October 10, 2012

**Subject: Response to DEQ Comments
Risk Assessment, Feasibility Study, and Source Control Evaluation
Swan Island Upland Facility, Operable Unit 4
ECSE No. 271**

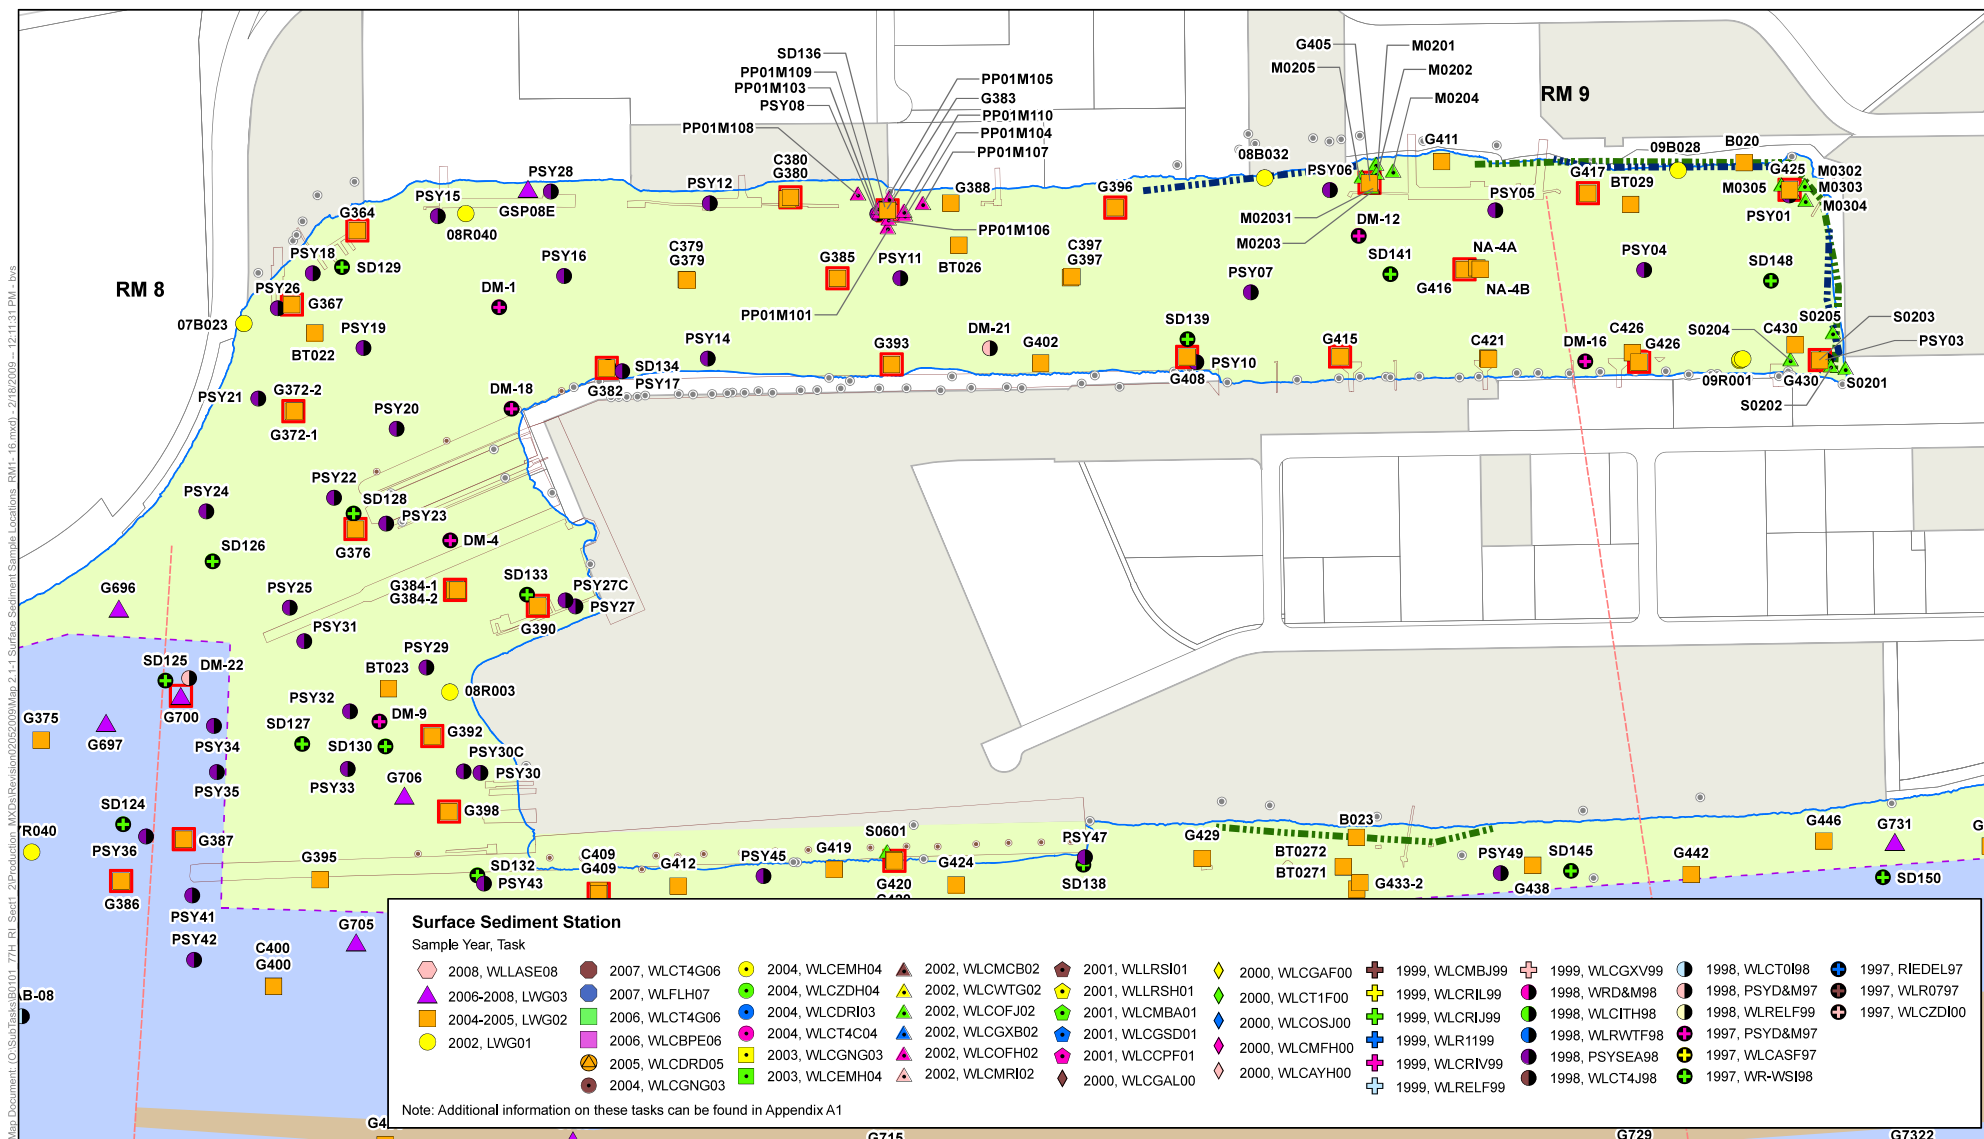
12. Section 6.1.2 Chemicals of Interest. *DEQ requests that a figure showing the locations of sediment samples presented in Table D-1 through D6 be submitted.*

Response. The noted sample locations are shown on Map 2.2-1k from LWG Draft Final RI report dated August 29, 2011. A copy of the Map is attached.
